Conceptual Review Agenda

Schedule for 07/25/16 to 07/25/16

W Laporte Ave. Single Family Dwellings

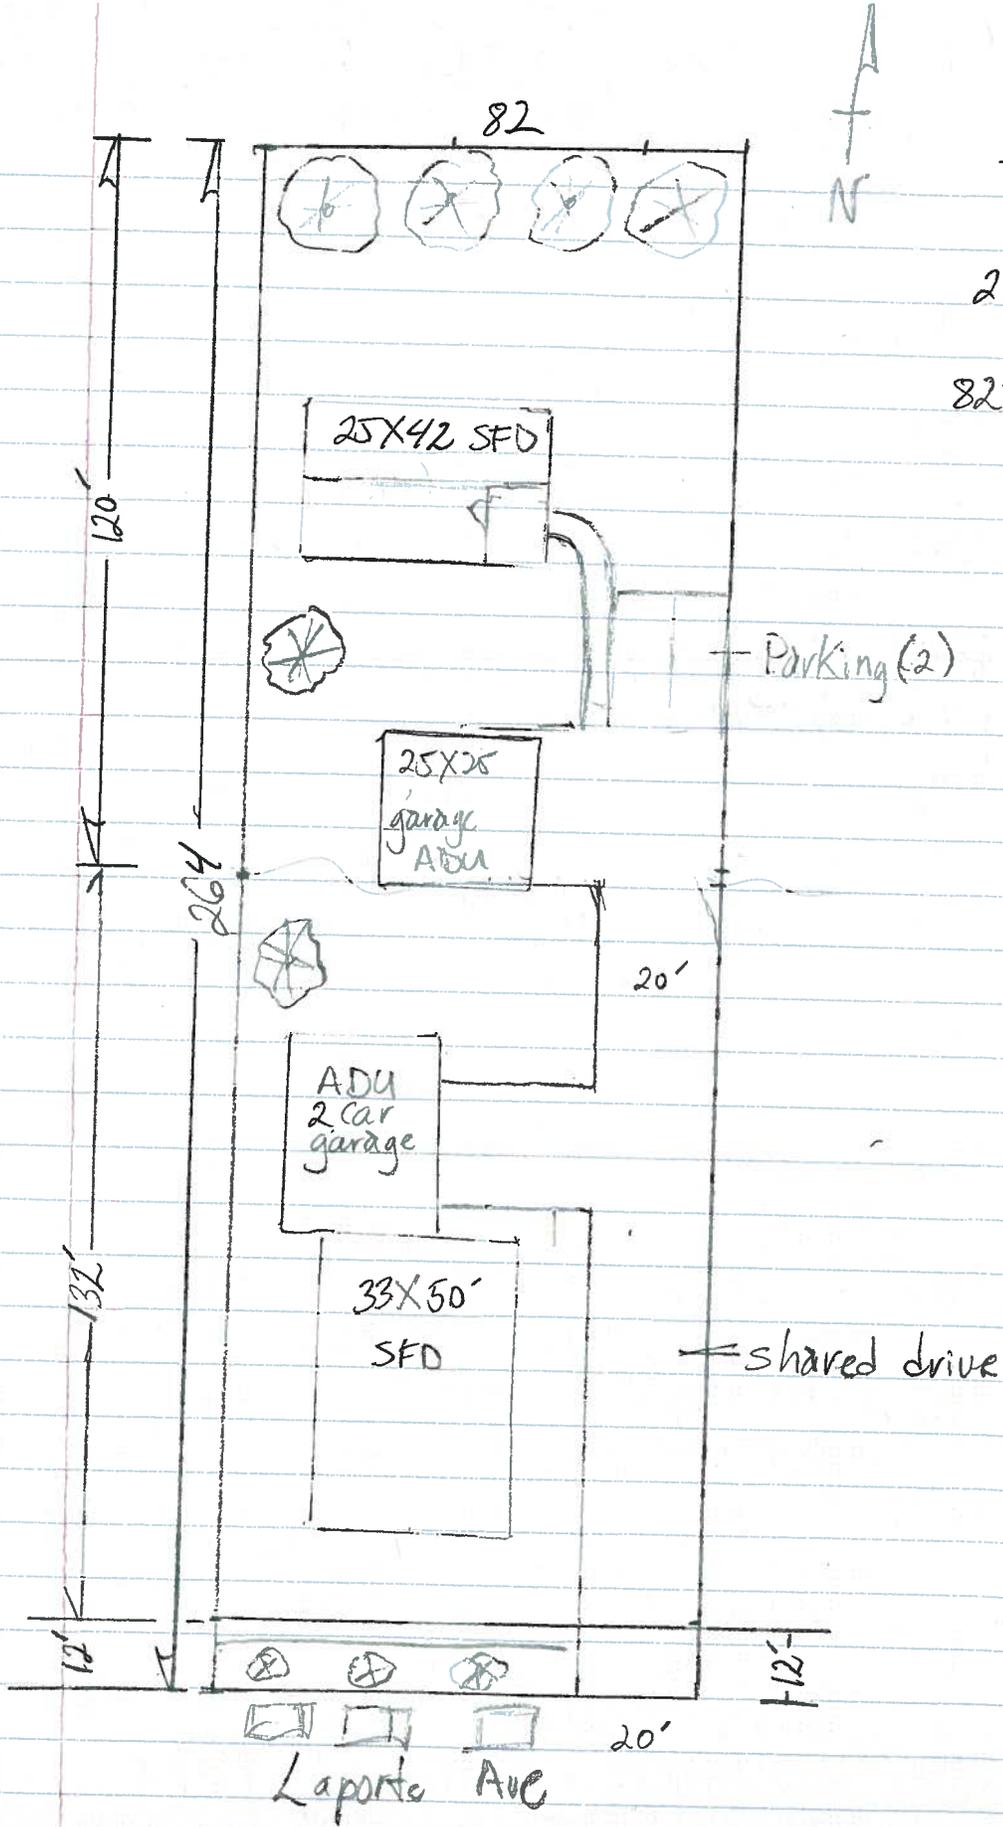
1. There are no connections shown to the sidewalk along Laporte. Land Use Code section 3.2.2(C)(6) requires direct connections to the pedestrian and bike network. Please show how pedestrians will be able to access the sidewalk network from this site without having to use the drive aisle.

11. The maximum size of the accessory structures is 800 sq. ft.
 12. The maximum size of the accessory structures is 800 sq. ft.
 13. Based on the configuration shown on your conceptual site plan, it appears you will meet the intent of garage door standards outlined in Land Use Code section 3.5.2(F). The garage in the rear should have windows or some other architectural features to make it appear more like a home from Laporte Ave.

17. Is it possible to shift the drive 5 feet to the west to allow space for a fence or landscape buffer? This would provide an improved buffer for your neighbor to the east.

TRACT 2-B

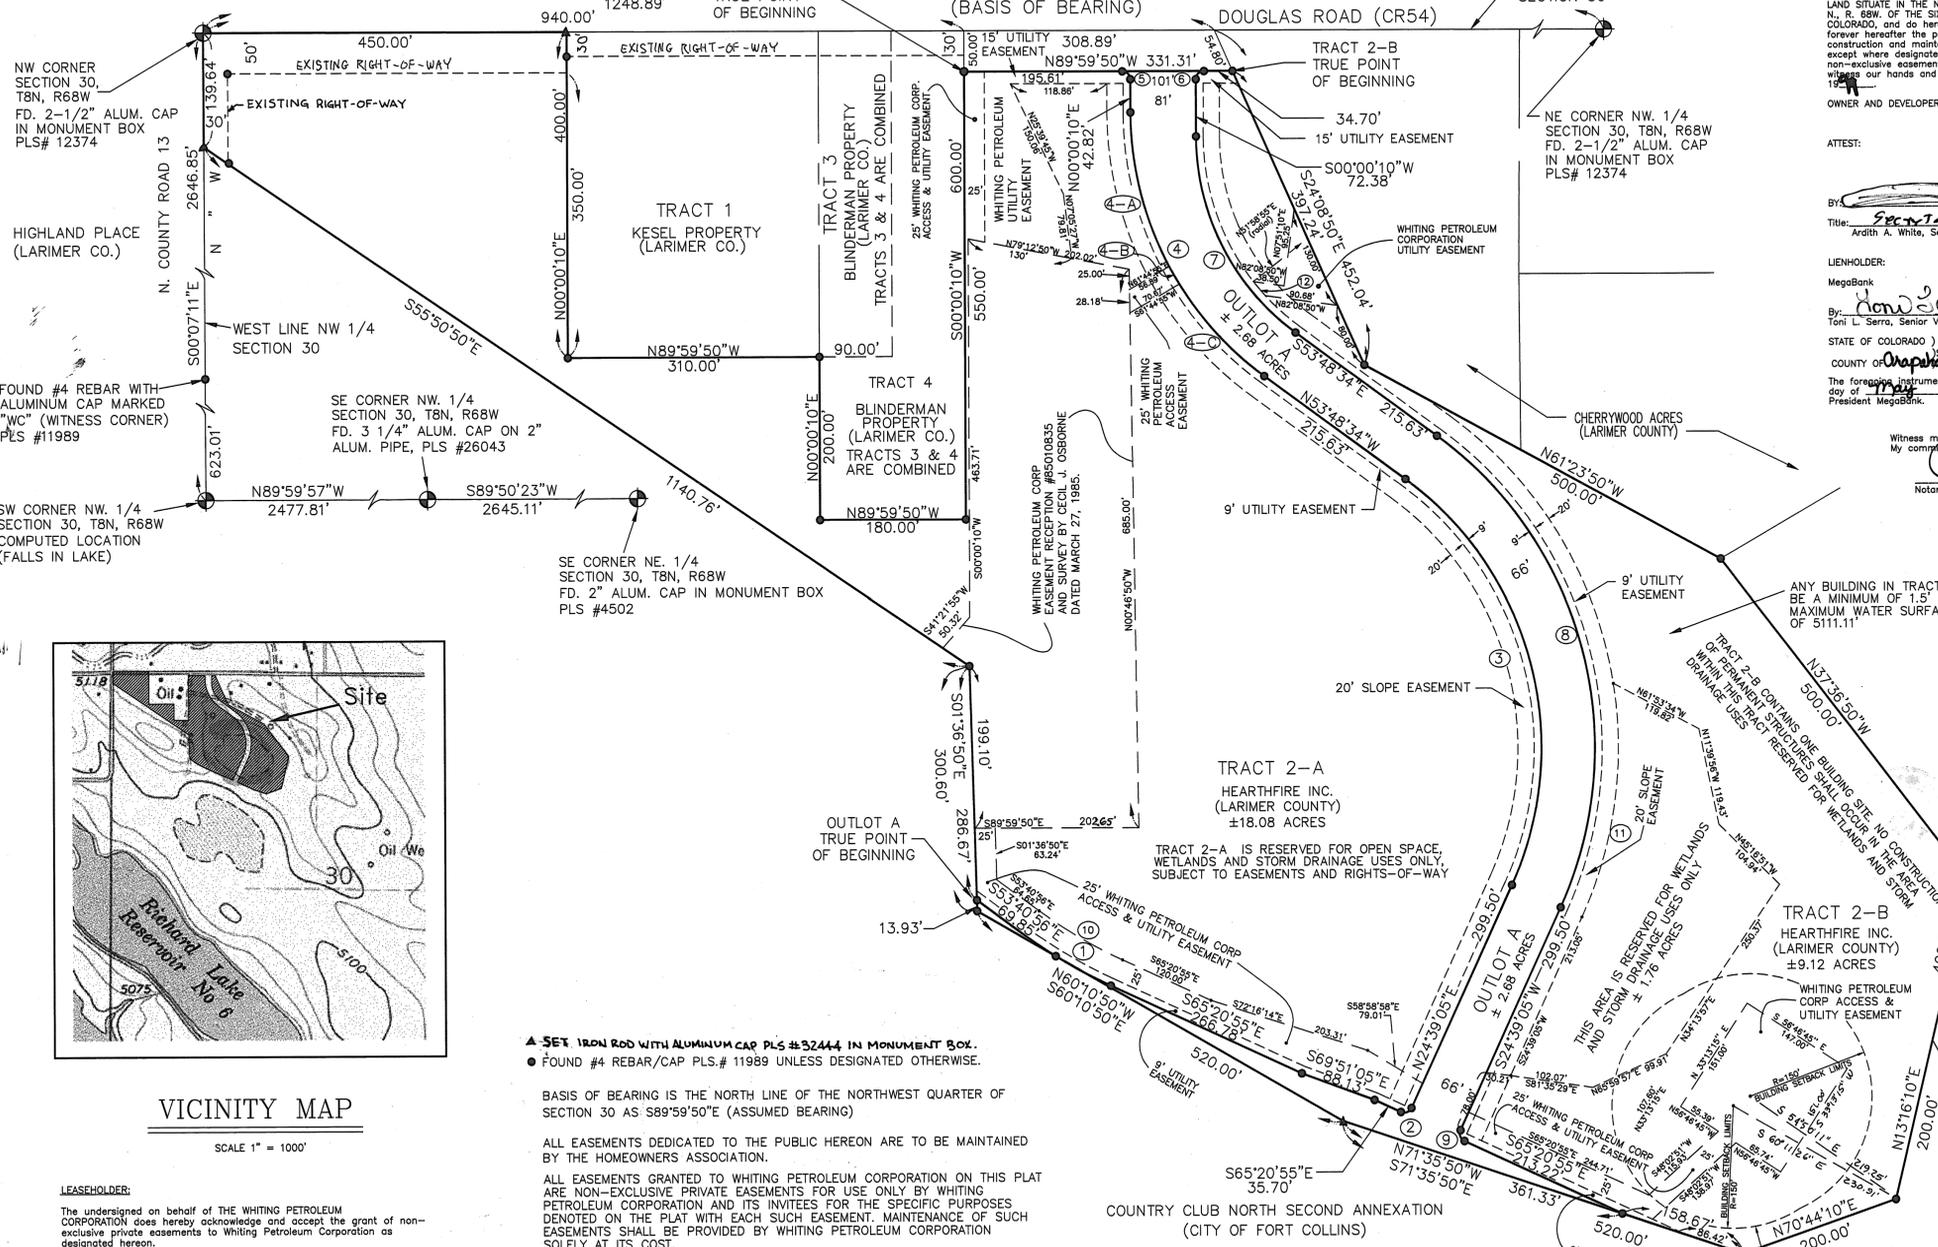
2. This tract, as shown on the Amended Exception Plat and as noted in the drainage map in the Hearthfire PUD Second Filing, this Tract 2-B is reserved for wetlands and storm drainage uses. Therefore, this site was not included in any previous development condition assumptions and will need to provide all required storm drainage infrastructure.
